AMENDMENT OF SOLICITATION/MODIFICATION OF CONTRACT

1. CONTRACT ID CODE	
2. AMENDMENT/MODIFICATION NO. Amendment 0005	3. EFFECTIVE DATE JULY 19, 2000
4. REQUISITION/PURCHASE REQ. NO. NRMAE000000020	5. PROJECT NO. (If applicable)
6. ISSUED BY CODE U.S. DEPARTMENT OF COMMERCE/NOAA ACQUISITION MANAGEMENT DIVISION IT CONTRACTS BRANCH, OFA 611 1305 EAST WEST HIGHWAY, ROOM 7604 SILVER SPRING, MD 20910	7. ADMINISTERED BY CODE (If other than Item 6)
8. NAME AND ADDRESS OF CONTRACTOR (No. Street, County, State and Zip Code) ALL OFFERORS IN THE COMPETITIVE RANGE Code: Facility Code:	<div> <input checked="" type="checkbox"/> 9.A. AMENDMENT OF SOLICITATION NO. 52-DDNR-0-90030 9.B. DATED (See Item 11) MARCH 28, 2000 </div> <div> <input type="checkbox"/> 10A. MOD OF CONTRACT/ORDER NO. 10B. DATED (See Item 13) </div>

AMENDMENT OF SOLICITATION/MODIFICATION OF CONTRACT
Solicitation No.: 52-DDNR-0-90030 **SF30, Page 3 of 4 Pages**
Amendment No.: 0005

Figure 6. Original Floor Plan and Schematic of Proposed New Design

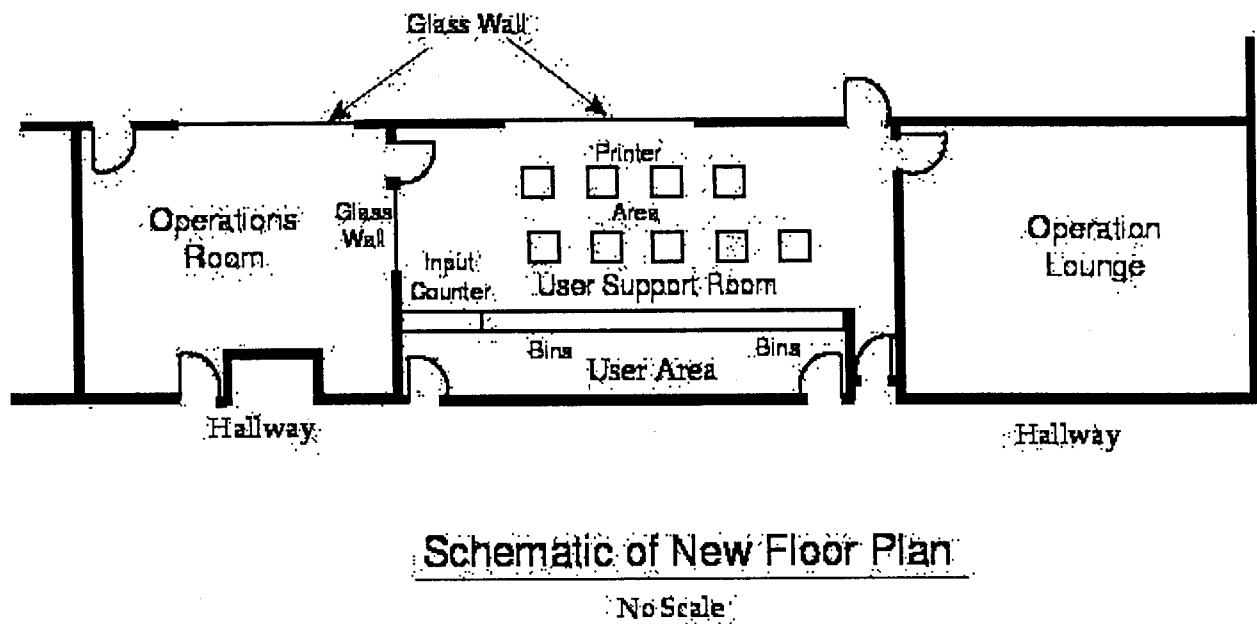
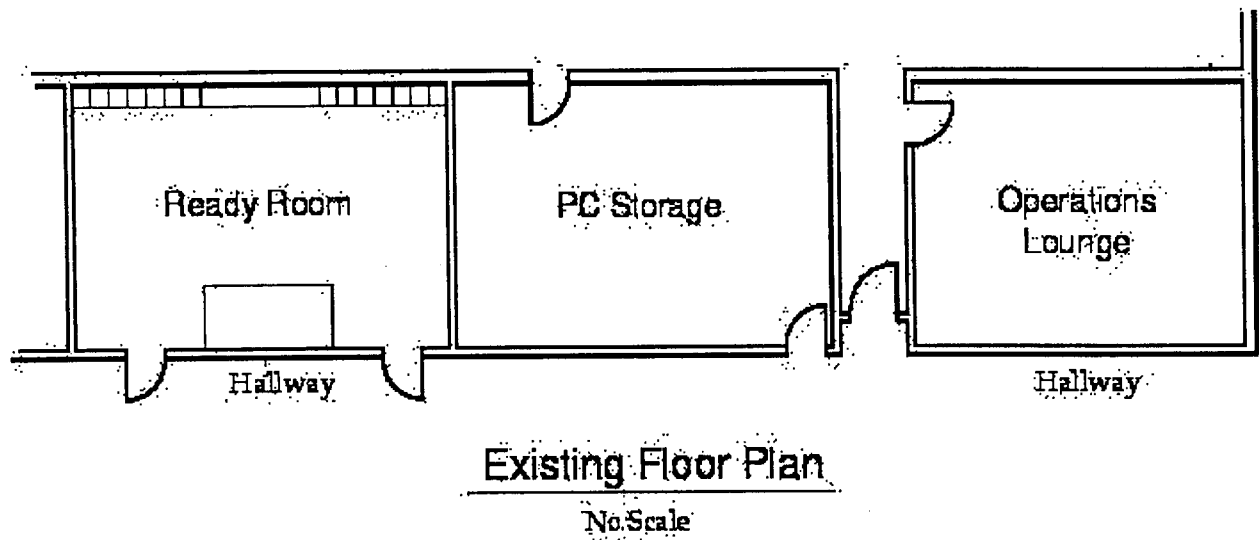
Also, a door between the Operations Room and the User Support Room was omitted in the Figure 6 drawing. A revised Figure 6 has been prepared that included the door. Page C-47 of the Solicitation should be removed and replaced with the enclosed Page C-47.

The upper frame of Figure 6 is an enlargement of the current layout of the Ready Room, PC Storage Room, and Operator's Lounge as taken from Figure 3. The lower frame of this figure shows a schematic of a proposed layout for the Operations Room and User Support Room and their position relative to the Operators' Lounge.
